Text proposal for STTD encoding of PCCPCH

Texas Instruments

April 15, 1999

Figure: STTD encoding for the data symbols of the PCCPCH is shown.

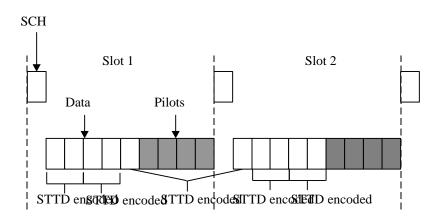
We propose the following text from [1] should be added to S1.11 to further clarify the STTD encoding of PCCPCH in S1.11 document.

The STTD encoding for the data symbols of the slots 1 and 2 of a PCCPCH frame is given in the figure below. The same procedure is used for the data symbols of slots 3 and 4, 5 and 6 and henceforth, respectively.
